Northville Downs Response to Dan Burden's Walkability Recommendations

Below is a response from the development team to Dan Burden's 20 recommendations he had presented in his Northville Walkability Study from December 21, 2021.

PROPOSED SITE PLAN

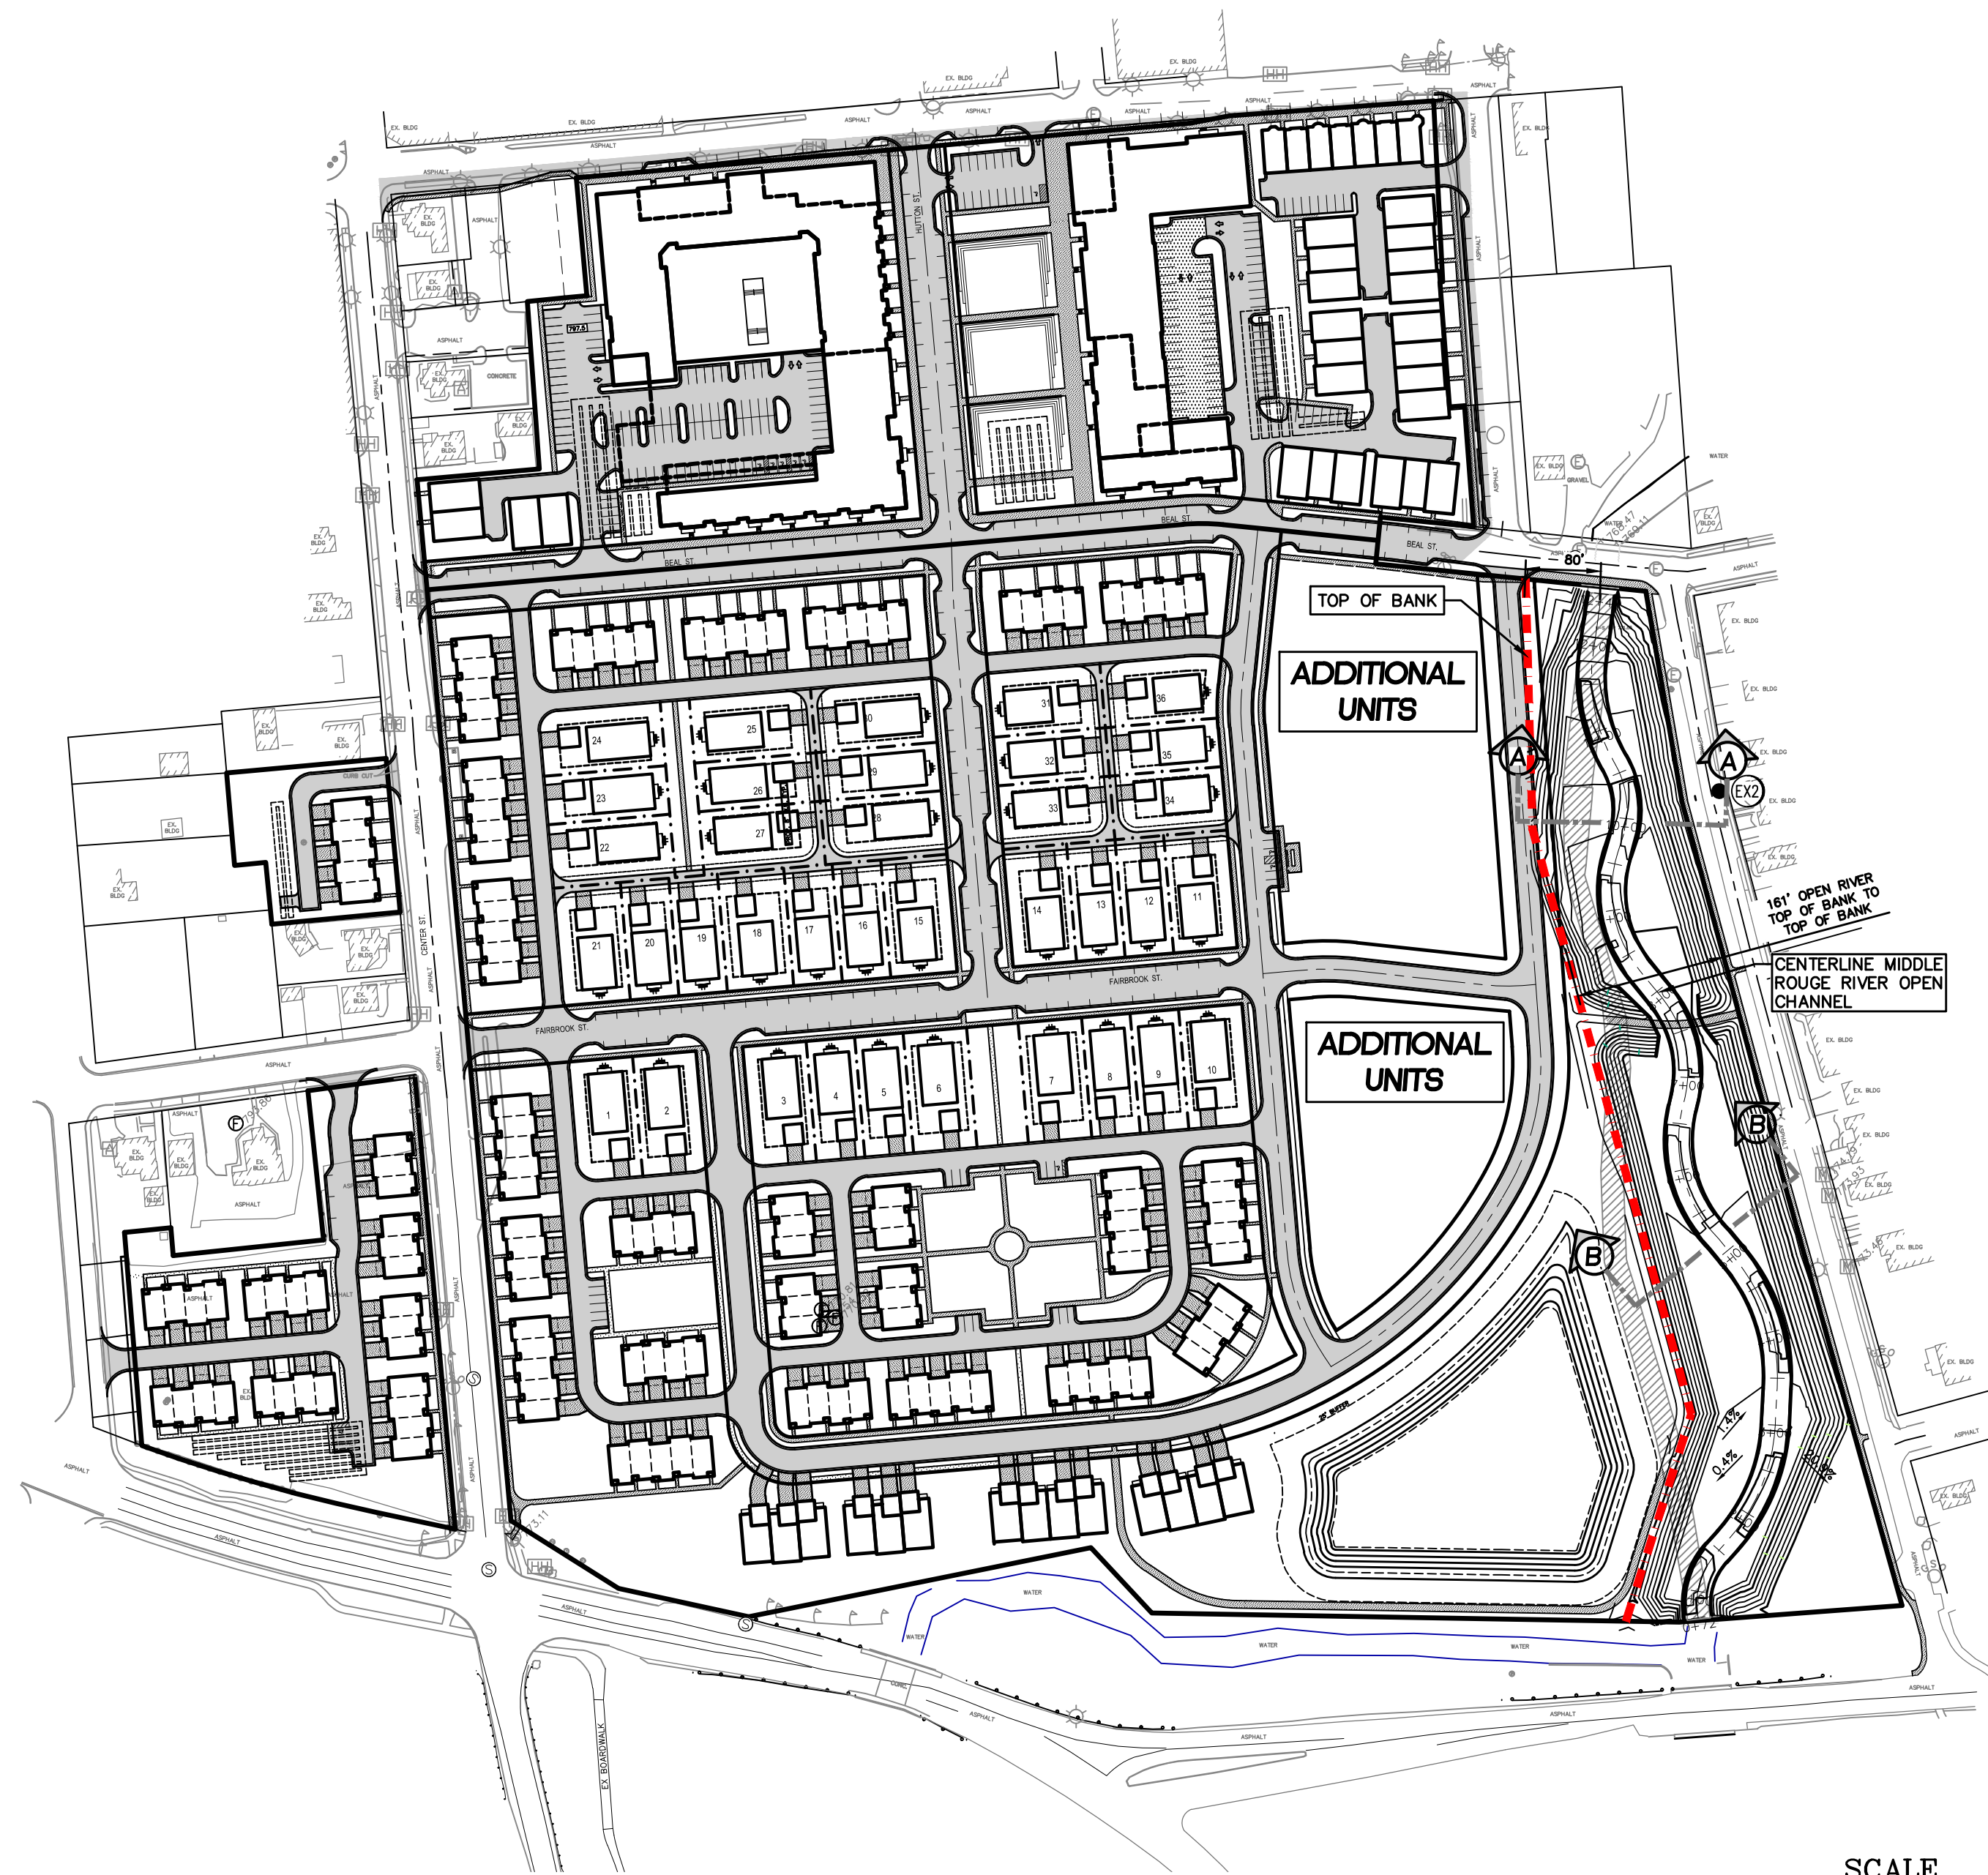
1. Eliminate the super block

2. Place the pond in the flood plain

3. Locate densities to build a center

5. Open access and views to the water

12. *Walk-first street design*
 - a. The site plan offers a pedestrian friendly, walk first street design. These conditions are indicated in the streetscape sections which are shown at key locations throughout the development. Sidewalks are provided along all roadways with a separation or "amenity" zone between the sidewalk and parallel parking for safety. The amenity zones contain street trees and within the Cady Street Overlay District, City standard lighting as well.

- a. The northern blocks fronting on Cady Street are broken up into three smaller sites with a one-acre park located between the NW and NE sites. Additionally, tree lined and landscaped pedestrian paths connect north to south through the sites between Beal Street and Cady Street. One is located at the west side of the NW block and the other between the NE and Griswold sites.

- b. The overall site plan addresses the current "super block" by the addition of an extension of Fairbrook St. to the east, extensions of Beal, Hutton and Church streets to the north, addition of the proposed central park and pedestrian promenade to the north and the previously noted pedestrian connection to River St. to the west. The pedestrian connections created throughout the site in the form of walkways, the bridge at the River Park and the promenade at the Central Park enhance the connectivity throughout the site, and its perimeter entry points.

- a. Wayne County and FEMA will not permit placing the detention pond in the flood plain.

- a. The highest density in the site plan is along Cady Street closest to the downtown area. The site plan provides a coherent commercial frontage along Cady Street with breaks at the one-acre park and at the north / south pedestrian paths. Along the park, building frontages step down from Cady to Beal Streets while providing a park enclosure at an ideal 1:3 portion of open space to facade height per New Urbanism design guidelines. The highest concentrated densities in the site plan are adjacent to Cady Street, at the northern most point of the site.

- a. The River Park will be designed to provide access from the North, East, and West sides of the park. Due to the location of the Johnson Drain to the south and the site, as well as the absence of a pedestrian sidewalk along 7 Mile Road, we do not provide access into the River Park from the south. Although, we are putting a pedestrian sidewalk along the

east side of the site along the west side of River Street, which will connect from 7 Mile road to Beal Street.

- b. Views to the water are incorporated in the plan, the daylighted river will be exposed along River Street, Beal Street, the end of Fairbrook Street, and the roadway off of Beal that goes through the Toll Brothers' site.

- b. The pedestrian friendly, walkable streets integrated throughout the development provide a high level of connectivity to the surrounding neighborhoods and downtown district.
